AGENDA
CORRIDOR IMPROVEMENT AUTHORITY
June 27, 2018 6:00 pm
Central Fire Station

Re: Commercial Planned Unit Development #18024 (Affinity 9 Investments, LLC), demolish existing restaurant and construct a new restaurant with drive-through window at 2080 Grand River Avenue.

Re: Mixed Use Planned Unit Development #18034 (Meridian Investment Group, LLC), construct 70,213 square foot mixed use building with 3,115 square feet of commercial space and 88 apartments.

- 1 COVER SHEET & AMENITIES PLAN
- 2 UTILITY PLAN
- 3 STORM & GRADING PLAN
- 4 PERVIOUS/IMPERVIOUS PLAN
- 5 EXISTING PLAN
- 6 LANDSCAPE PLAN

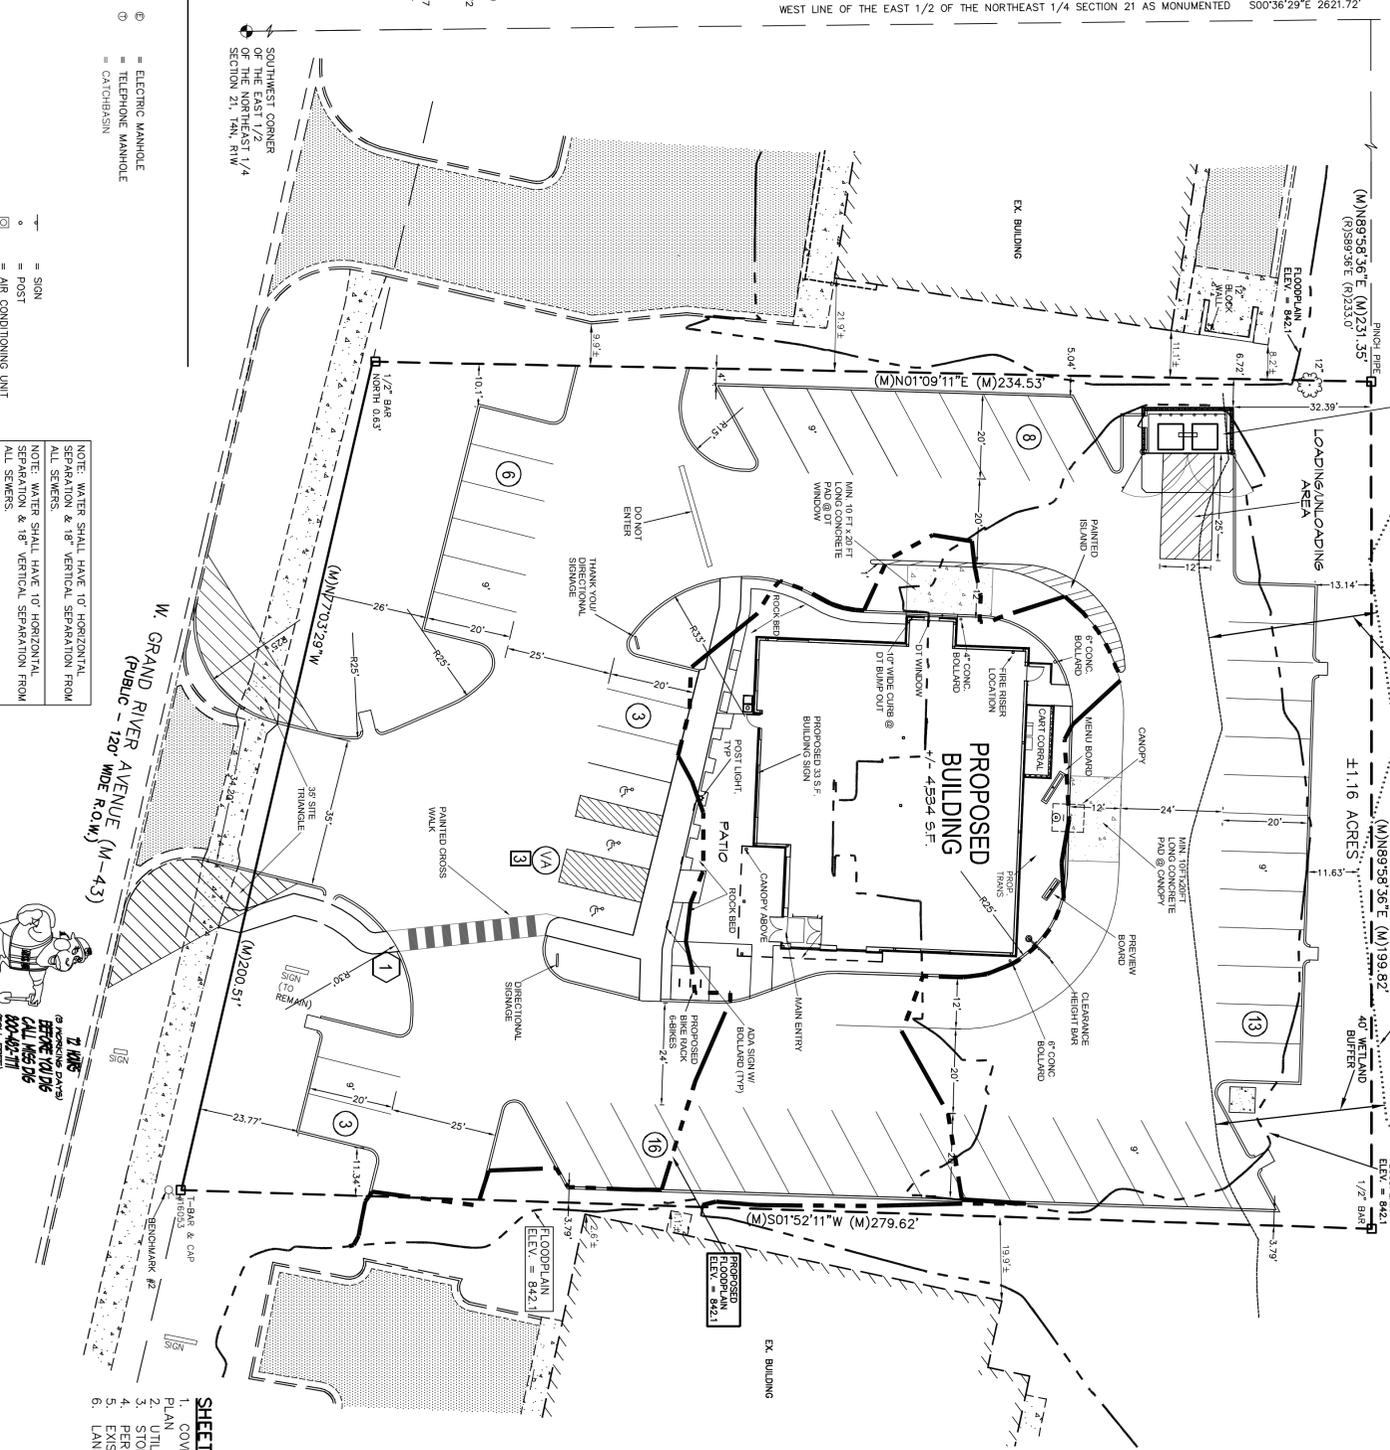
Sheet 1 of the submitted site plan shows the proposed amenities for the project, including connection to the pedestrian-bicycle pathway along Grand River Avenue and public Wi-Fi.
